Interactive comment on “Modelling the hydrological interactions between a fissured granite aquifer and a valley mire in the Massif Central, France” by Arnaud Duranel et al.

Received and published: 7 August 2020

Fig. 1. Selected Electrical Tomography Resistivity transects across the study site. The transect locations are shown on Figure 1.

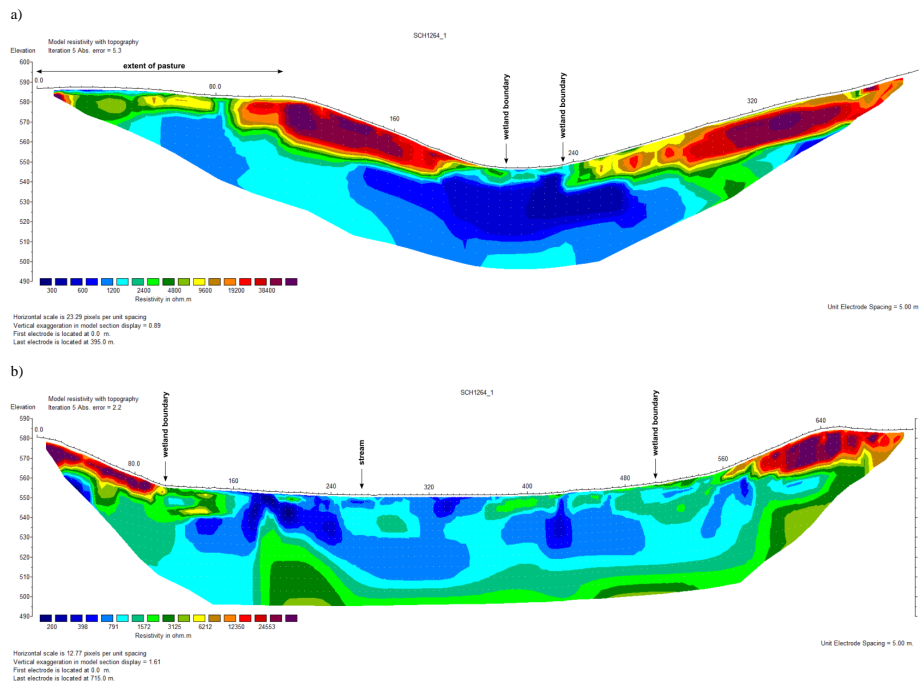
Figure 1 of this reply shows the presence of conductive material underneath much more resistive material on the hilltops and slopes of the catchment. The transition between these layers is abrupt and its altitude is largest beneath hilltops. The depth of the transition is larger beneath steep slopes, and on all transects it intersects the surface topography in the valley precisely where the wetland boundary is located (taking into account the ERT positional accuracy). The only location where conductive material was recorded above resistive material is on one hilltop (visible on the left-hand side of transect a). This was interpreted as demonstrating that most of the material investigated corresponds to the densely fissured layer of a truncated granite weathering profile. The interface between resistive and conductive material was assumed to correspond to the groundwater table (the exfiltration of which led to the formation of the wetland). The increase in resistivity with depth at the very bottom of transect b) at a depth of around 55m below ground level was interpreted as a decrease in fissure density (and therefore bulk porosity), and a transition towards unweathered granite. The superficial conductive material on the hilltop was assumed to be (probably unsaturated) saprolite, which is more conductive than the fissured granite layer due to its larger clay and water contents. The configuration was not seen anywhere else within the study area, leading to the conclusion that on most hilltops and hillslopes the majority of saprolite has been eroded away and the combined thickness of the soil, periglacial deposits and remaining in-situ saprolite is too small (less than a metre) to be detected. There is no indication of the presence of a substantial saprolite layer in the valley bottom beneath the wetland, however the complete saturation of the profile may make the distinction between fissured granite and saprolite impossible in this area. Figure 2 of this reply shows that the granite is weathered to highly weathered, with dense fissuration leading to low or variable core recovery percentages, to a depth of 15-65m. A substantial saprolite layer (“grus”) is present in five out of seven locations. This is seemingly at odds with the apparent absence of saprolite beneath the wetland on the ERT transects located further downstream. However it should be noted that the geological drillings are not representative of the entire catchment as they were undertaken within a small

Fig. 2. Geological drillings by the Commissariat à l’Energie Atomique, showing the granite weathering grade and the core recovery percentage. The drilling locations are shown on Figure 1.

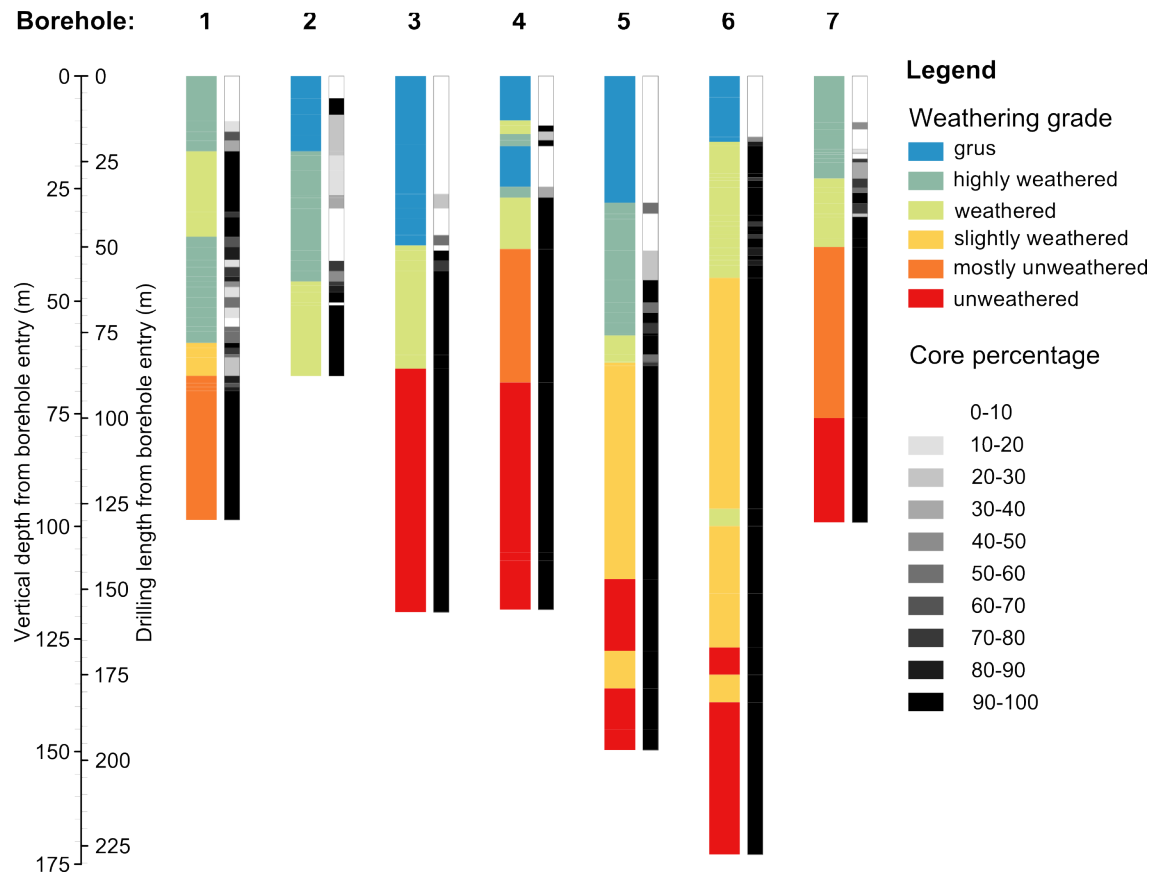
area along uranium-rich mineralised faults of tectonic origin, which may have led to a more pronounced weathering locally. Our interpretation of the ERT and geological data agrees with the current understanding of granite weathering processes, granite landscape geomorphology and granite hydrogeology in the Massif Central in general and in the Monts d'Ambazac specifically (Desire-Marchand and Klein, 1986; Dewandel et al., 2006; Godard et al., 2001; Klein, 1978; Klein et al., 1990; Mauroux et al., 2009).

Fig. 3. Simulated mean annual groundwater table depth and seepage rates in the wettest (January) and driest (September) months (2001–2013).

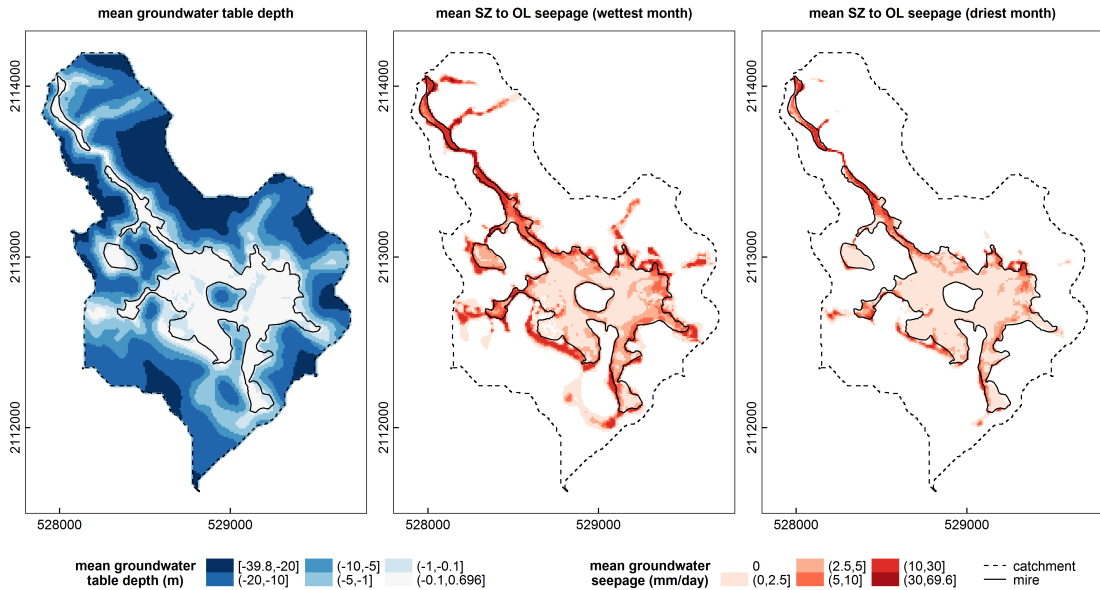
Figures 10 and 11. We believe that Figure 11 is interesting in showing the progressive decline in the seepage rate from winter to late summer, and the almost perfect agreement between areas where seepage still occurs in September and the mire extent. We do, however, also acknowledge that the figure takes a large amount of space. Therefore we propose to move it to the Supplement. In revising the manuscript, we will follow the recommendations of Referee #2 and produce a new figure replacing Figures 10 and 11 in the main paper. As recommended, this figure will show the mean groundwater table depth, and the mean seepage rates in the driest and wettest months. Figure 3 of this reply provides a draft of the proposed new figure.
